Product Change Notification

Date Issued :	September 17, 2022	PCN Number :	512550
Reason for Change :	Change Supplier		
Description of Change :	This notification is to inform you about change of supplier impacting the part(s) attached as per list, No changes will be made to product as part of this change.		
Reason for Short Notice :	Supplier Constraints		
Assessment of Change :	First Article Inspection		
Planned Implementation Date :	December 20, 2022		
Sample Availability Date:	October 02, 2022		
Internal Molex Qualification Date :	December 05, 2022		
Last date to request Samples by Customer :	December 01, 2022		
Traceability Code Markings / Date :	Date code

CFD- Metal 590459985

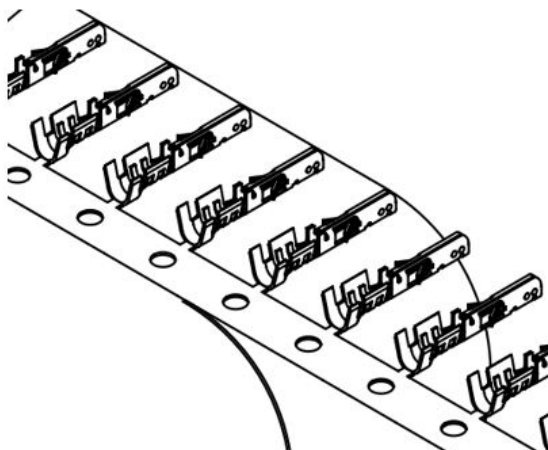
- Because current vendor JX Nippon stopped producing C26000 metal alloy, we must qualify new source Xingye to keep production running. Metal alloys are not changed. Xingye is one of local metal supplier in China.
- Product Impact
 - no impact to fit, form or function
 - ✓ Before: C26000 SP PL 0.203 X 19.81 P/N:590459985
 - ✓ After: C26000 SP PL 0.203 X 19.81 P/N:590459985
 - ✓ Product will be fully qualified before it is shipped. Qualification reports will be available after below listed date.
